Publication No. 1F8761
15JUL03

MODIFICATION INSTRUCTIONS for the *Kodak X-Omat* MULTILOADER 7000 Service Code: 3444

Modification No. 8
Type 1 Selective

Purpose: To upgrade to the Operating Software V_1.24 for the *Kodak X-Omat* MULTILOADER 7000. The Operating Software V_1.24 will prevent the error “CA AB” for the CASSETTE.

H186_0712HCA
H186_0712HC

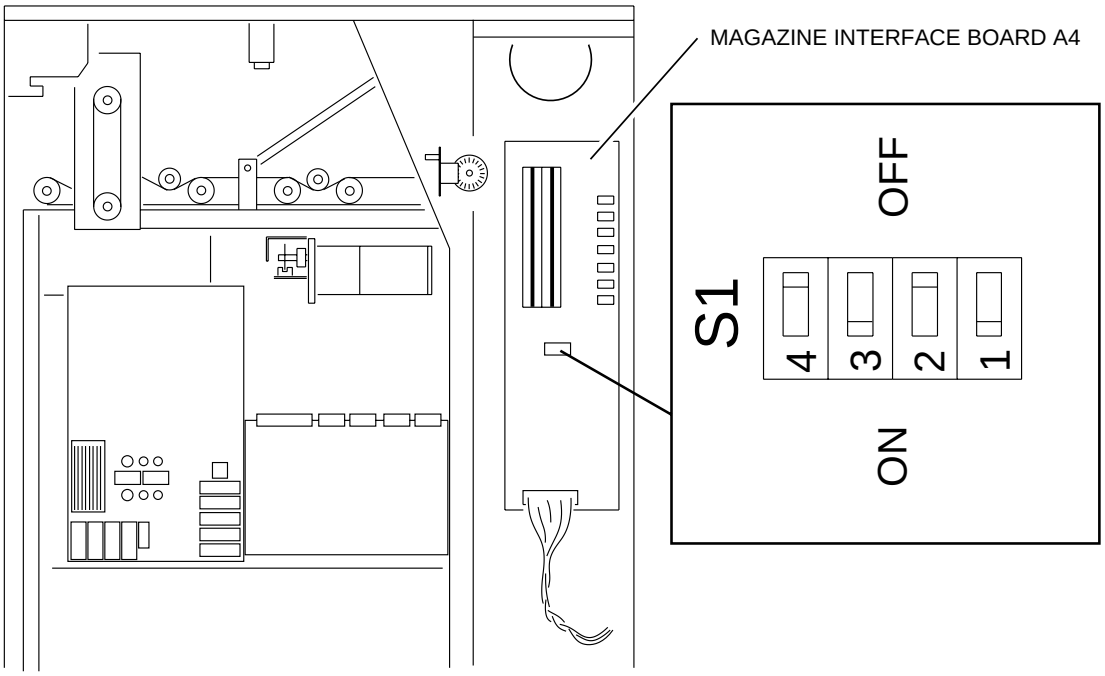
[6] On the MAGAZINE INTERFACE BOARD A4, move S1-1 to “ON”.

With the S1-1 in the “ON” position, the “pocket delay” is increased by one second. The “pocket delay” is the time that the MAGAZINE SUCKERBAR waits inside the CASSETTE after the MAGAZINE SUCKERBAR loads the film.
